Access Compliance Report

Public Rights-of-Way

(Curb Ramps)

Intersection ID: 54151	Main Street: SANDERS_FARM_LN	Cross Street: WALNUT_FOREST_DR	Location: NW
ADA ID: 1C632C6DBD34	Ramp Type: Perp	Initial Pass/Fail: Fail	Overall Compliance: No
Severity Score: 8.75			
Codes/Mitigation Info/Possible Solution		Field Measurements/Component Compliance

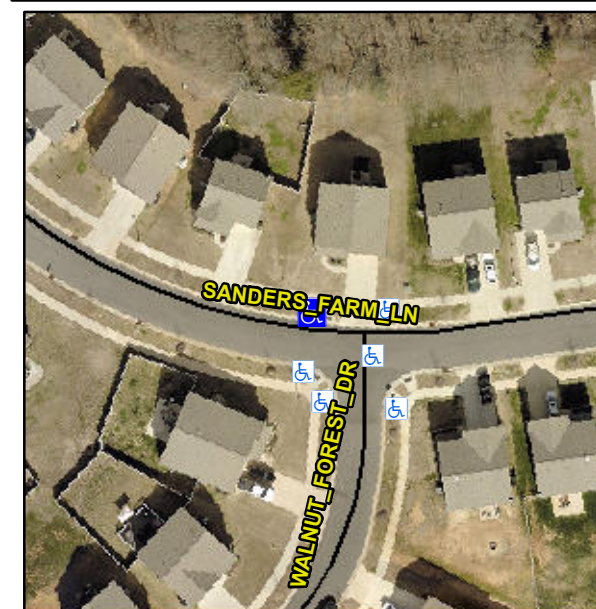
Compliance	Description	Data	Compliance	Description	Data
N/A	Ramp Length (in)	96.0	Yes	Ramp Slope (%)	8.2
No	Ramp Width (in)	44.5	Yes	Ramp XSlope (%)	0.9
N/A	Flare Type LT	N/A	N/A	Flare Type RT	N/A
N/A	Flare Slope LT (%)	N/A	N/A	Flare Slope RT (%)	N/A
N/A	Flare Traversable LT?	N/A	N/A	Flare Traversable RT?	N/A
N/A	Landing Length (in)	N/A	N/A	DWS Provided?	N/A
N/A	Landing Width (in)	N/A	N/A	DWS Contrast?	N/A
N/A	Landing Slope (%)	N/A	N/A	DWS Length (in)	N/A
N/A	Landing X Slope (%)	N/A	N/A	DWS Full Width?	N/A
N/A	Landing Curb? (Y/N)	N/A	N/A	DWS Offset (in)	N/A
N/A	Shared Landing?	N/A			
N/A	Gutter Ponding?	N/A	N/A	Gutter Slope (%)	N/A
N/A	Gutter Lip Ht (in)	N/A	N/A	Gutter X Slope (%)	N/A
N/A	Painted X Walk1?	No	N/A	Painted X Walk2?	N/A
	X Walk 1 Direction	To S		X Walk 2 Direction	N/A
N/A	X Walk 1 Width (in)	N/A	N/A	X Walk 2 Width (in)	N/A
	X Walk 1 Slope (%)	4.3		X Walk 2 Slope (%)	N/A
	X Walk 1 X Slope (%)	2.2		X Walk 2 X Slope (%)	N/A

N/A	Ramp inside XWalk1?	N/A	N/A	Ramp inside XWalk2?	N/A
	Road Slope (%)	N/A	N/A	Clear Space?	N/A
	Road X Slope (%)	N/A	N/A	Clear Space to XWalk (in)	N/A
N/A	Any Obstructions?	N/A	N/A	Storm Grate/Utility Hazard?	N/A
	Obstruction Type			Storm Grate/Utility Type	
		N/A			N/A
			Yes	Surface Condition? (G/P)	Good

Remove & Replace Entire Ramp.
